Proposal Request

Project:
Intermountain Healthcare Lake Park Level 1 Remodel
2545 College Drive
Murray, Utah 84123

Date: 02/11/2021
Proposal Request
PR # 01

C2 LEVEL 1 INTERIOR FINISH PLAN
A1101 SCALE: 3/32" = 1'-0"

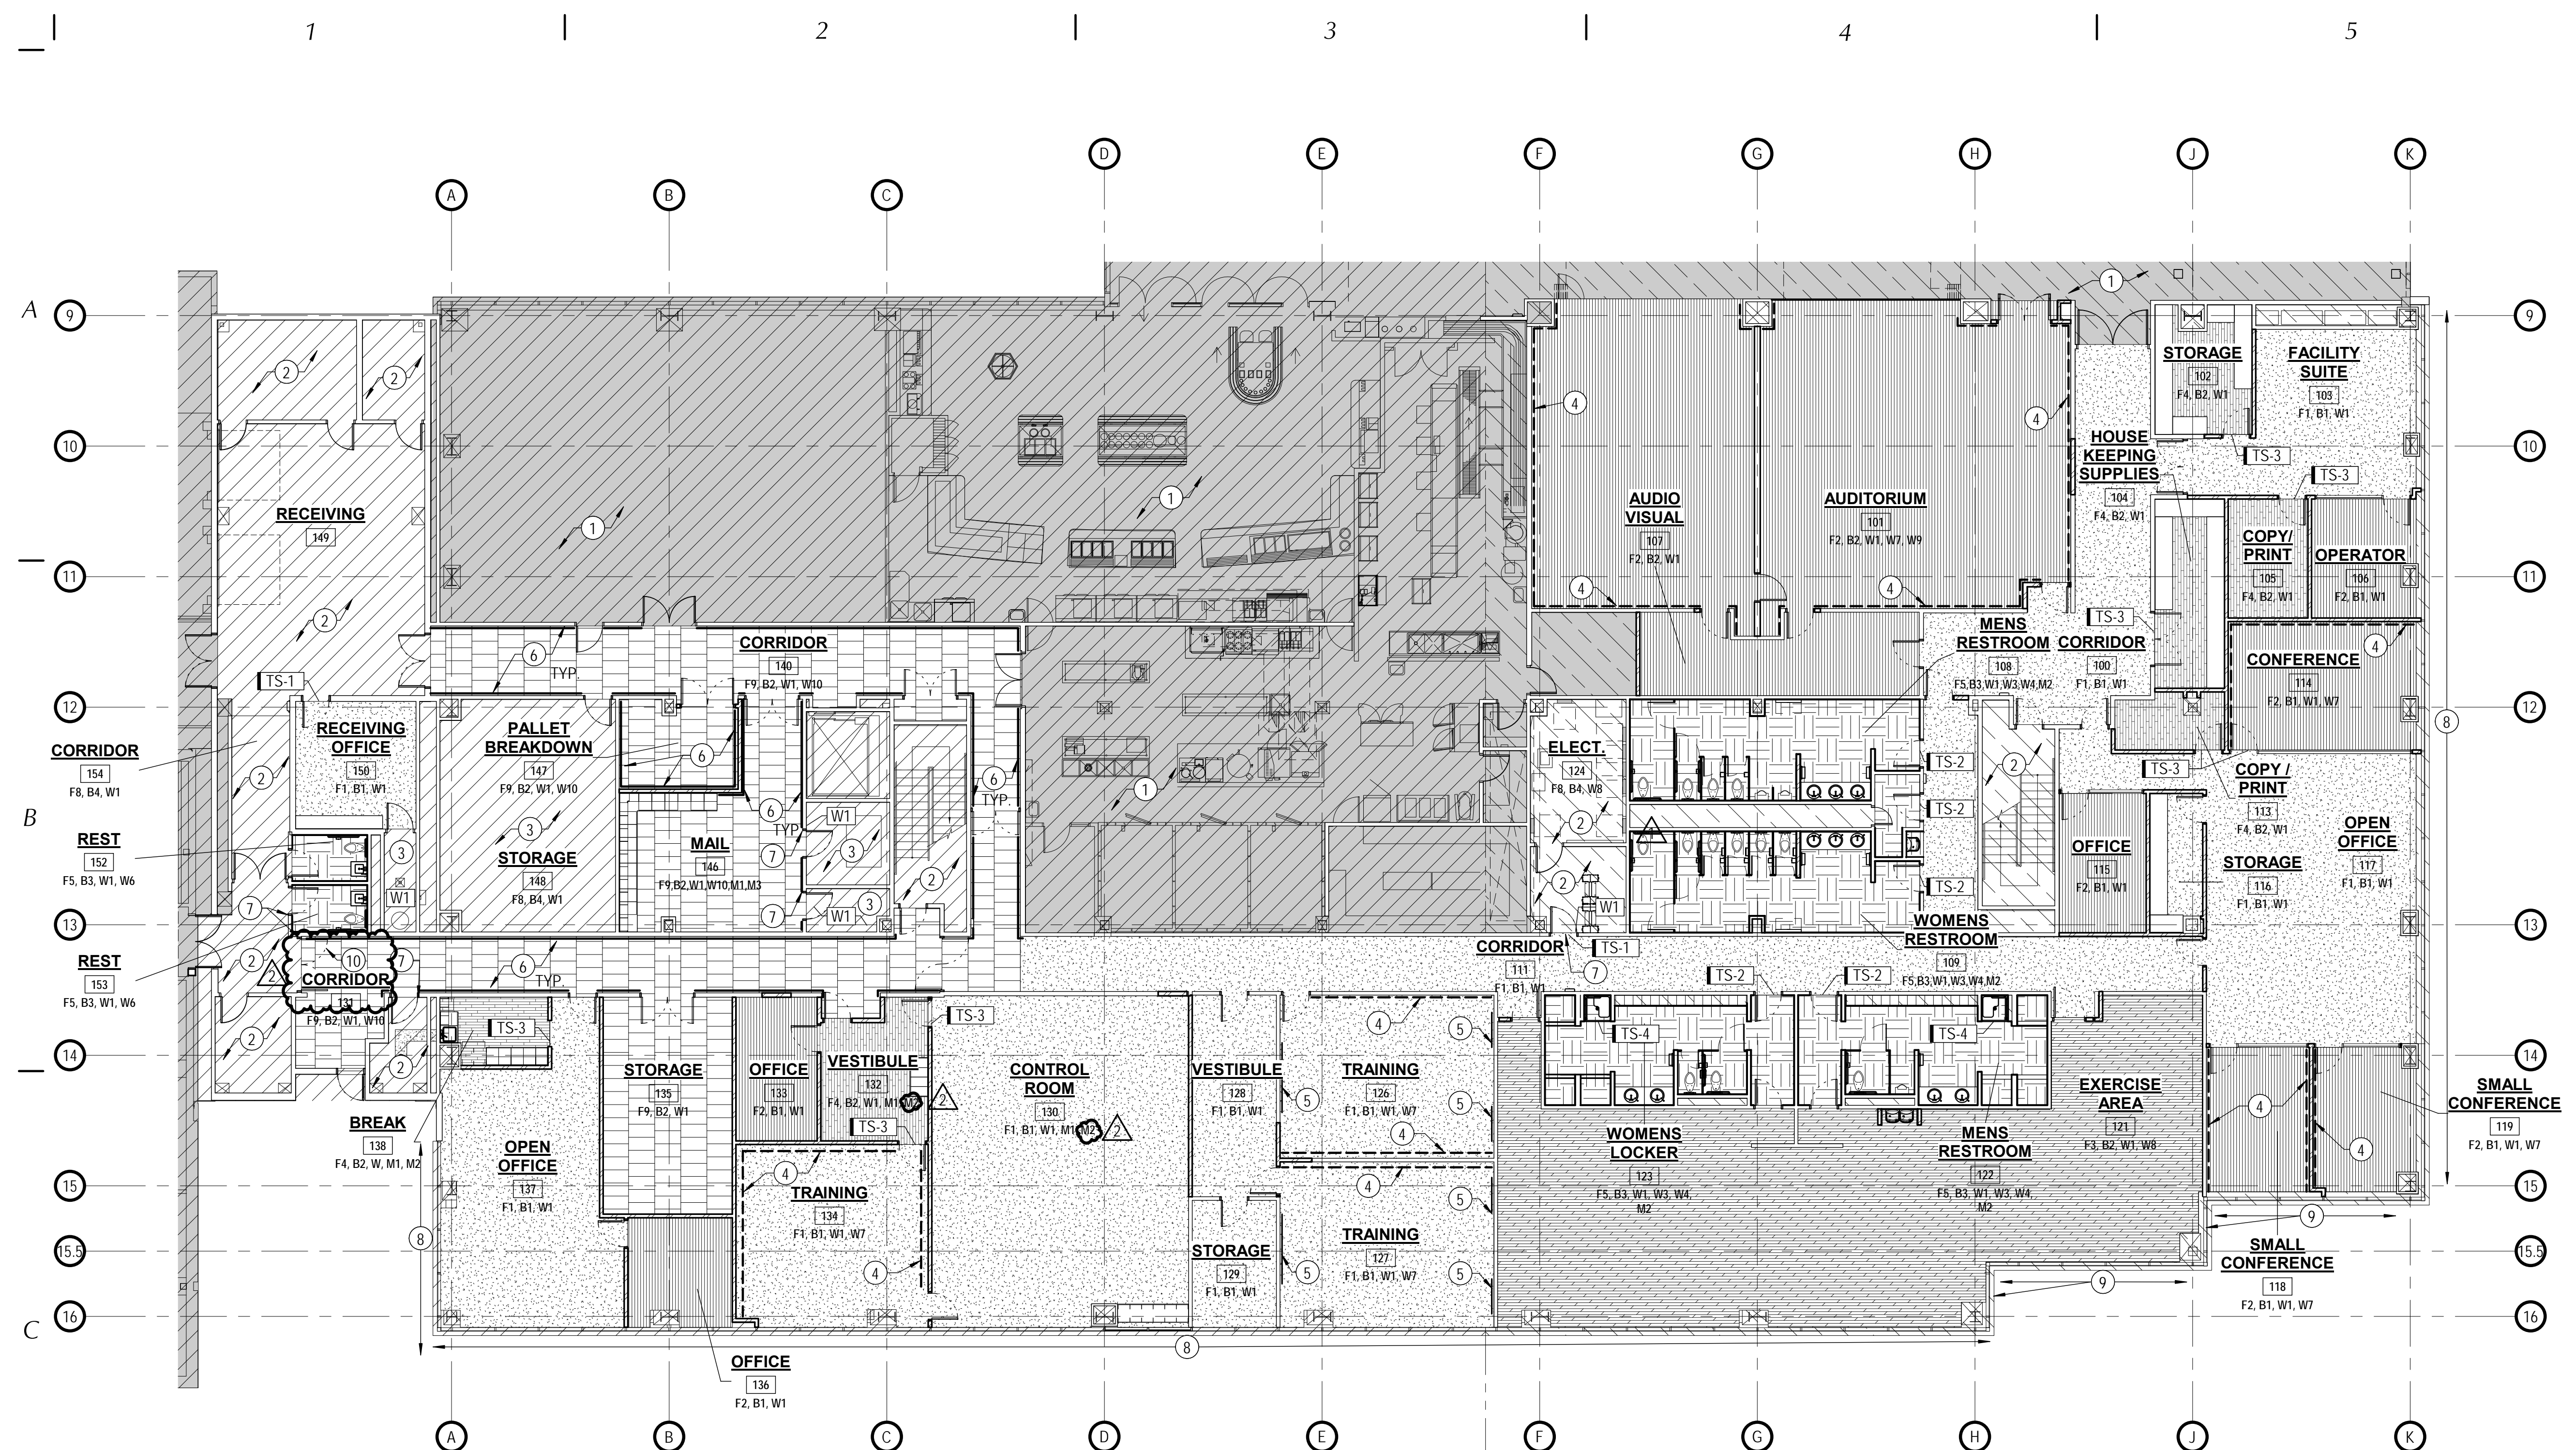
6. **Countertop Modifications:** Per Owner request, some modifications have been made to the countertop designations. The M3 designation has been changed to Wilsonart Shadow Zephr 4857-60 Matte Finish. The countertop type has been changed in Control Room 130 and Vestibule 132 to M2. See the revised A1101.

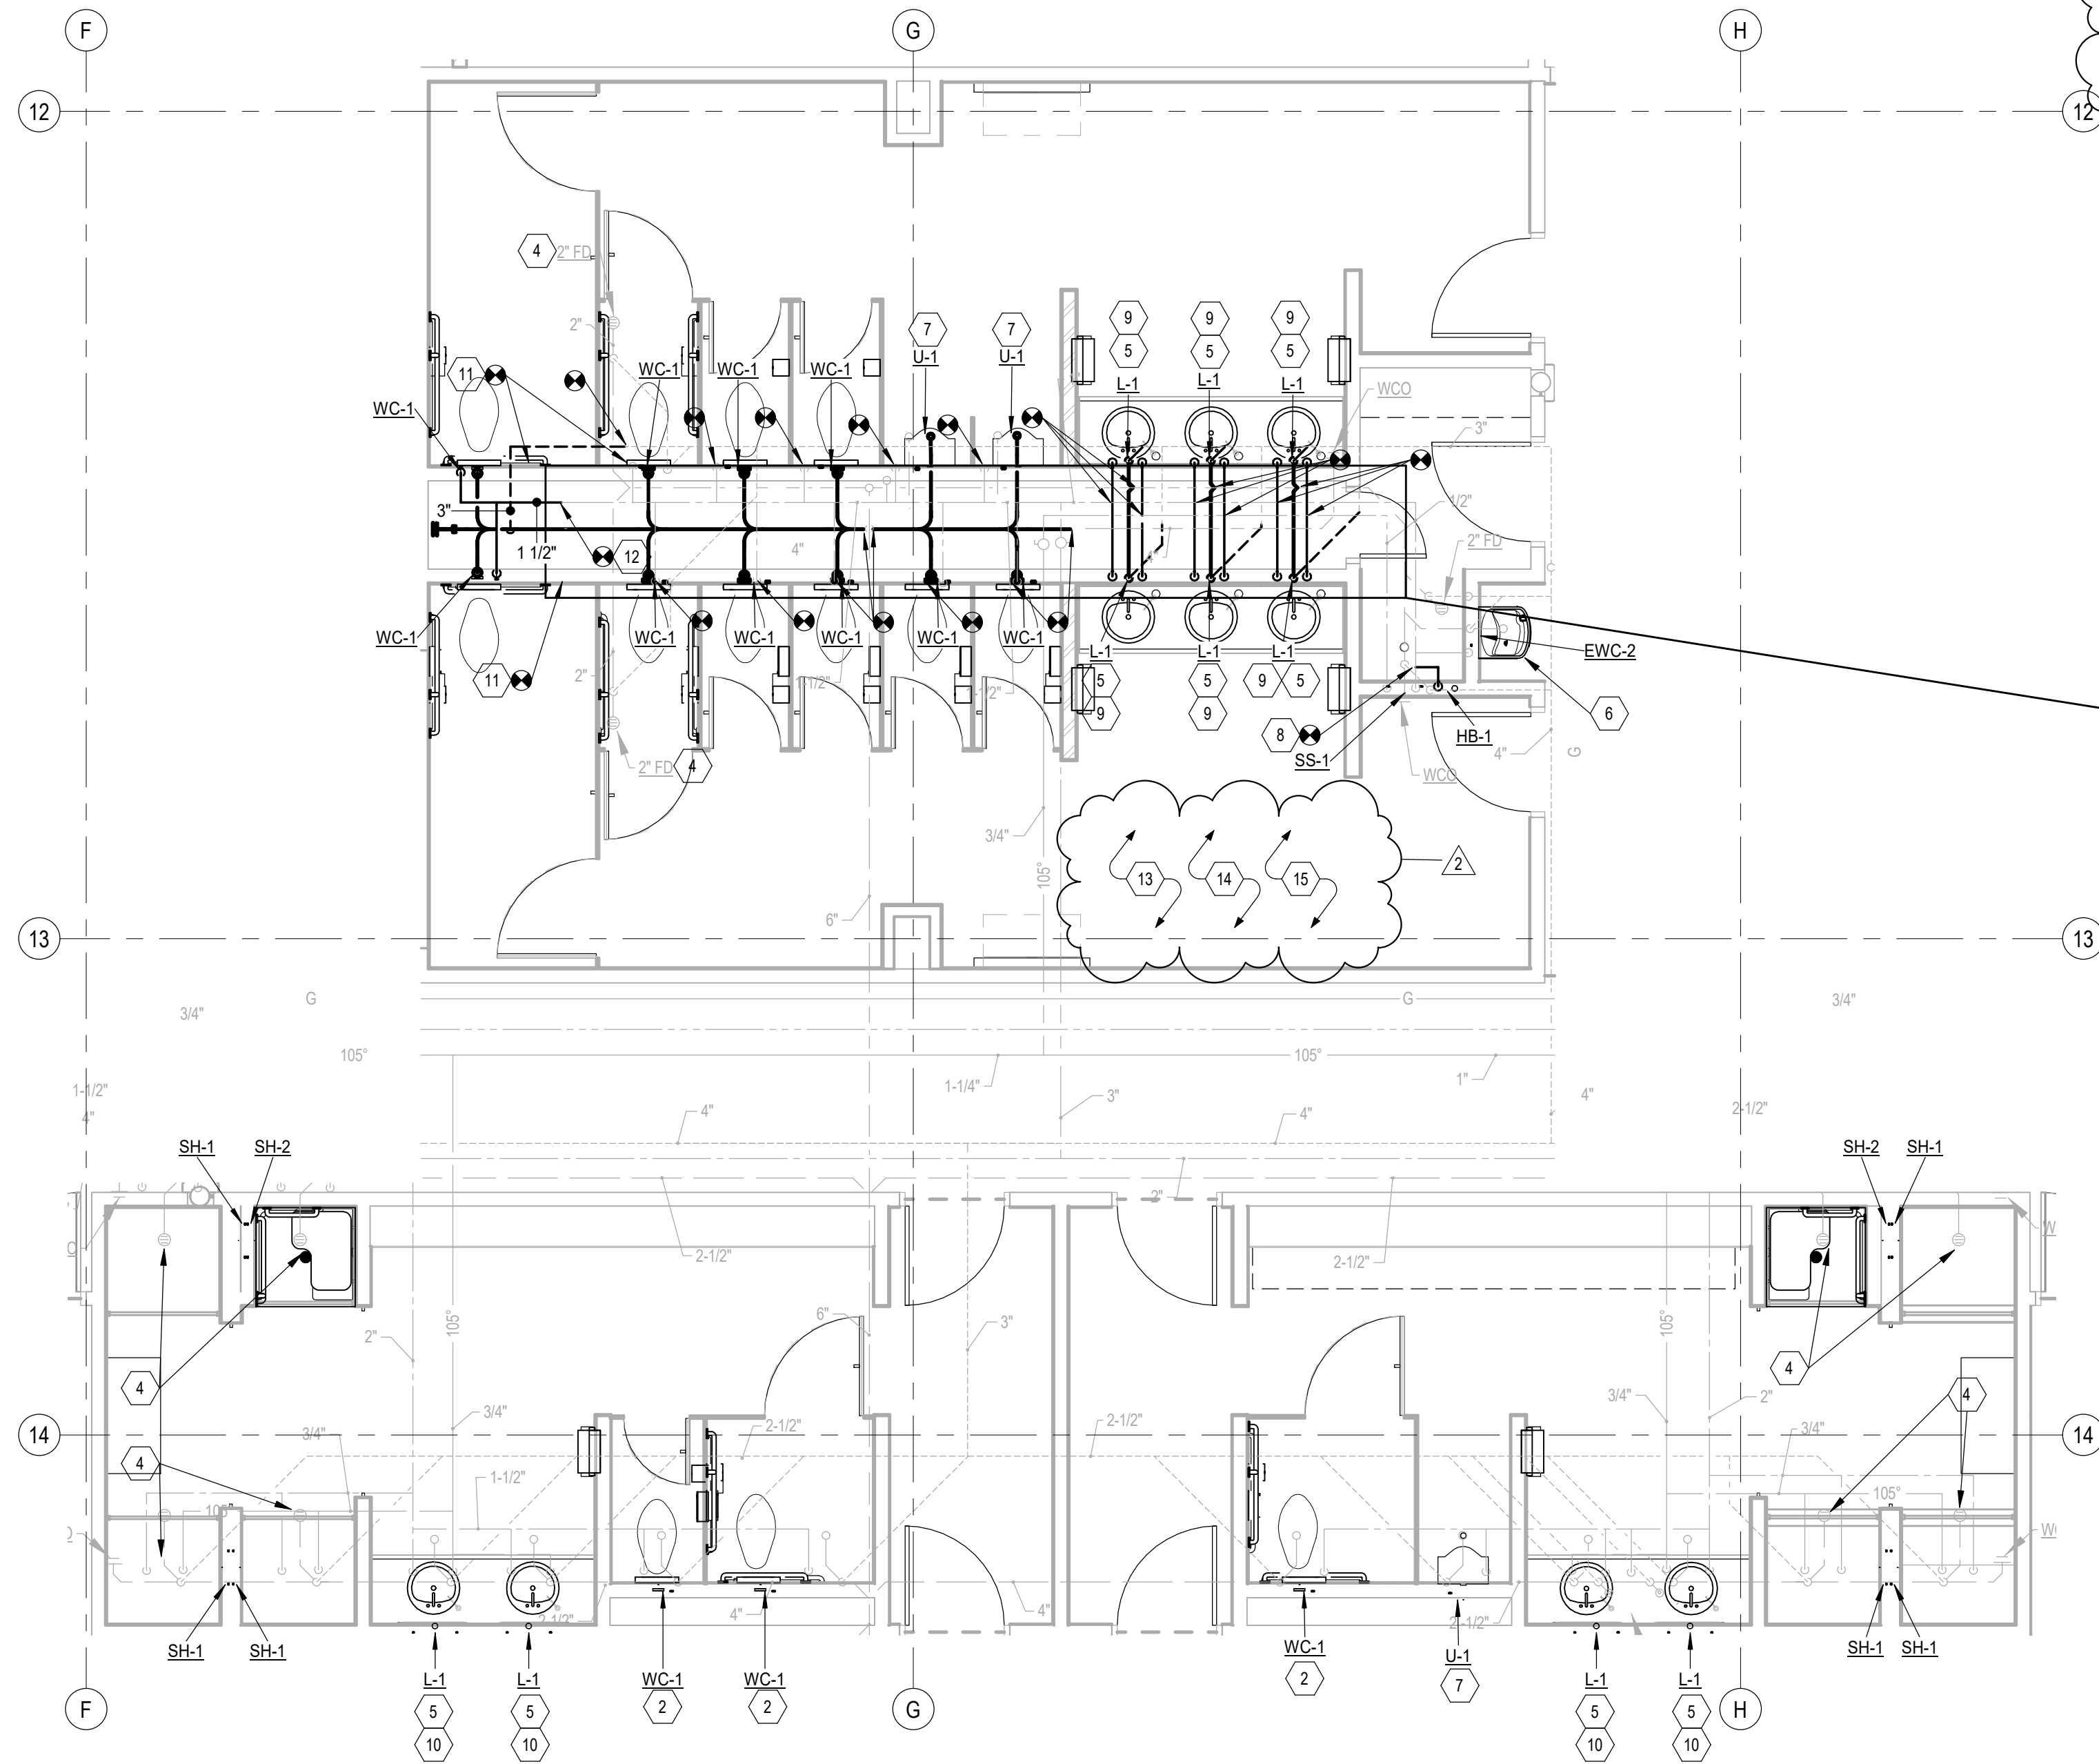
- Sewer District Comments:** During the city plan review process, we were required to submit to the sewer district. The sewer district required us to include some notes to specific sheets. See the revised. The owner's group requested the extension of the existing Data room walls to go to deck. This resulted in the elimination of the existing ceiling and lighting, which caused the addition of new wall mounted lights and relocation of the new mechanical grilles. See the Mechanical Narrative, and the revised PP101, and PP401.

SHEET - PP101 –PLUMBING PLAN LEVEL 1

1. Keyed note 14 added to the drawing.

- 13. PROJECT SHALL COMPLY WITH ALL UTAH DIVISION OF DRINKING WATER RULES AND REGULATIONS INCLUDING, BUT NOT LIMITED TO THOSE PERTAINING TO BACKFLOW PROTECTION AND CORSS CONNECTION PREVENTION.
- 14. A DYE TEST OF THE SANITARY AND GREASE SEWER IS REQUIRED AND SHALL BE CONDUCTED PRIOR TO GRANGER-HUNTER IMPROVEMENT DISTRICT FINALL ACCEPTENACE.
- 15. IT IS THE CONTRACTOR'S RESPONSIBILITY TO VERIFY THE LOCATION OF ALL GREASE AND SANITARY SEWER LINES BEFORE CONNECTIONS ARE MADE.
